ADDENDUM NO. 2

LEMON TOWNSHIP
Butler County, Ohio
South Main Street Reconstruction
September 3, 2015

Re: Lemon Township, Butler County, Ohio
South Main Street Reconstruction

SOUTH MAIN ST. PAVEMENT RECONSTRUCTION DETAIL

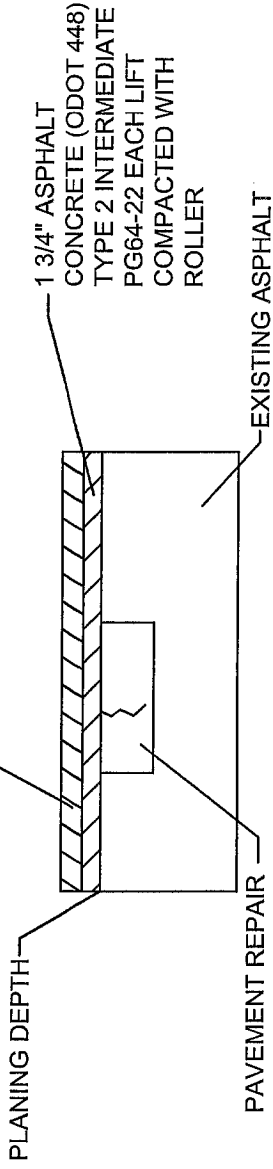
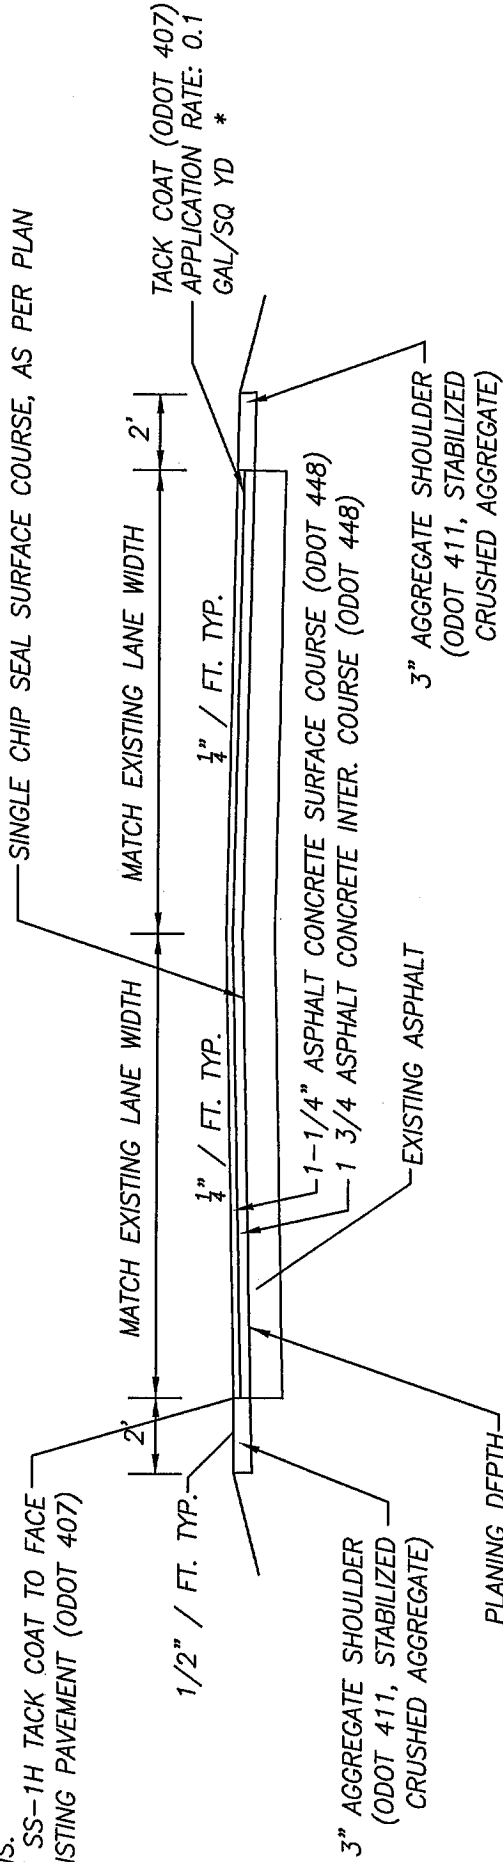
- A. The South Main Street Pavement Reconstruction Detail shown on this Sheet #2 of 3 shall be replaced with the South Main Street Pavement Reconstruction Detail shown on the attached sheet entitled “Addendum #2 – Project Details”. This detail removes the ODOT 206 12” Cement Stabilized Subgrade from the project and adds 3” of pavement planing. The ODOT Item 422 Single Chip Seal Surface Course, As Per Plan, remains a project component and has been added to the Typical Detail since it was inadvertently left out of the original Detail. Adjustments to the Bid Form reflect the change in Estimated Quantities from those originally shown on this Sheet #2 of 3.
- B. A detail for ODOT Item 253 Pavement Repair, As Per Plan, is being added to the project for South Main Street based on the Pavement Repair Detail shown on the attached sheet entitled “Addendum #2 – Project Details”.

PAVEMENT REPAIR DETAIL
 (ODOT 253)

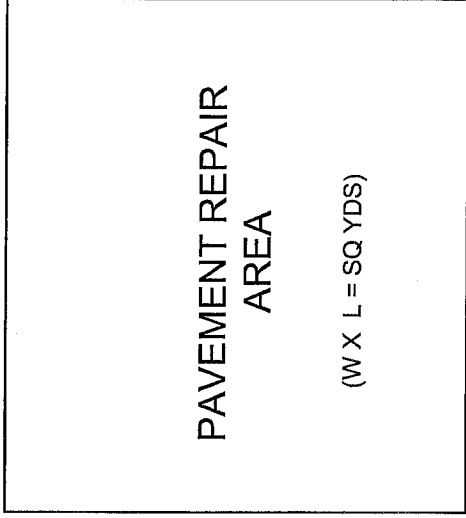
- B) ODOT Item 206 Cement Stabilized Subgrade and Cement shall be removed from the project.
- C) ODOT Item 253 Pavement Repair, As Per Plan, shall be added with a 100 S.Y. contingency quantity to address any areas that may need repair after the pavement planing has taken place. This work will only occur as directed by the Engineer and shall be completed in accordance with the Pavement Repair Detail shown on the attached “Addendum #2 - Project Details”.

SOUTH MAIN ST. PAVEMENT RECONSTRUCTION DETAIL

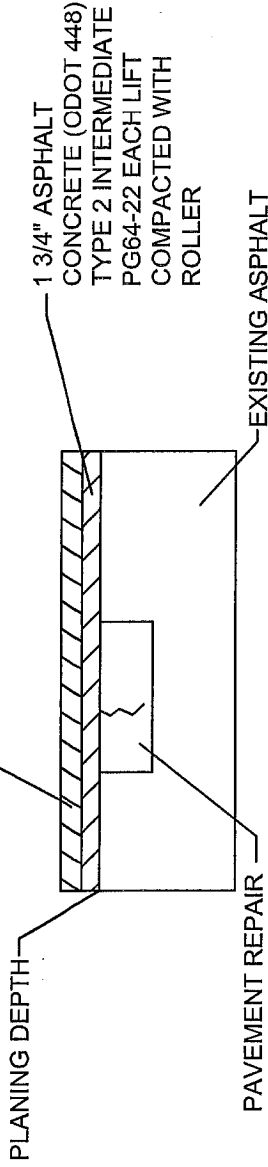
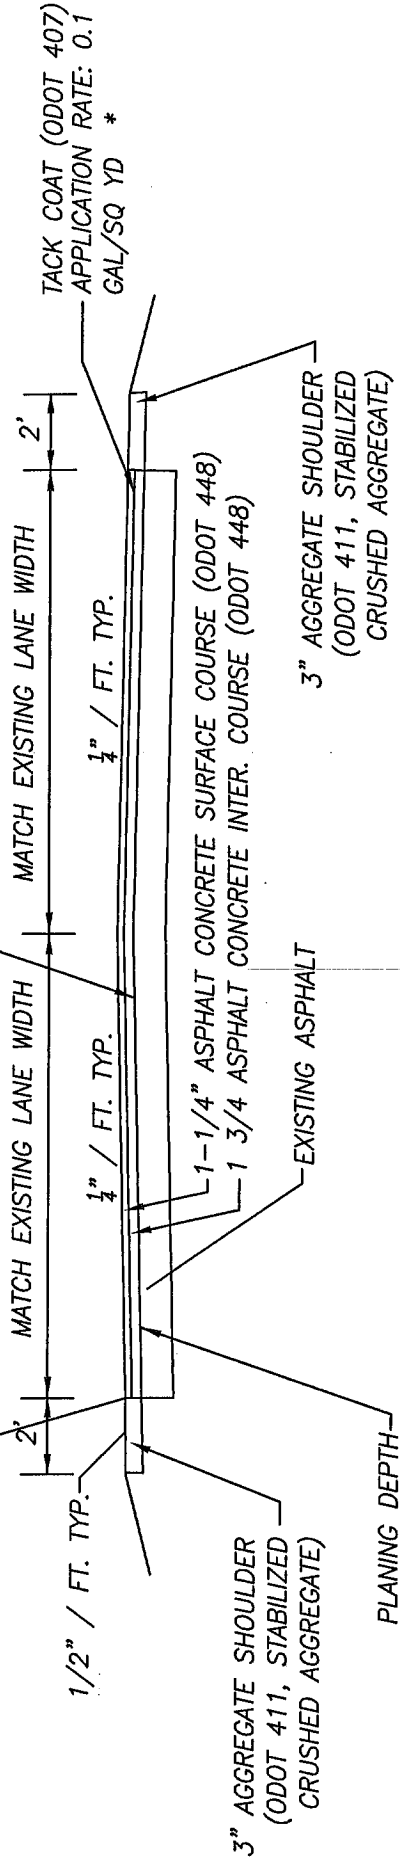
Alternate Bid #3 has been added to the project to place Star Grid G+PF material, or an Engineer approved equal, in lieu of the ODOT Item 422 Single Chip Seal Course (see detail). The product provides a moisture barrier and retards reflective cracking. It is manufactured by Luckenhaus Technical Textiles and distributed through PS Construction Fabrics, Inc. with a contact of Ted Howard at 330-335-3635.

- A. A project detail for the addition of Alternate #3 has been attached hereto. Alternate #3 will provide for placement of a Star Grid material between the planed surface and the ODOT Item 448 Asphalt Concrete Intermediate Course in lieu of placing the ODOT Item 422 Single Chip Seal Course in the same location. Bidder’s will provide a unit price cost for this option. Should this option be chosen, the single chip seal course item will be removed from the Base Bid.

STAR GRID G+PF APPLIED INTO A 'PG 64-22 TACK COAT'. COST OF PG 64-22 TACK COAT SHALL BE INCLUDED IN COST OF 'STAR GRID', TACK APPLICATION RATE = 0.15 GAL/SQ YD.
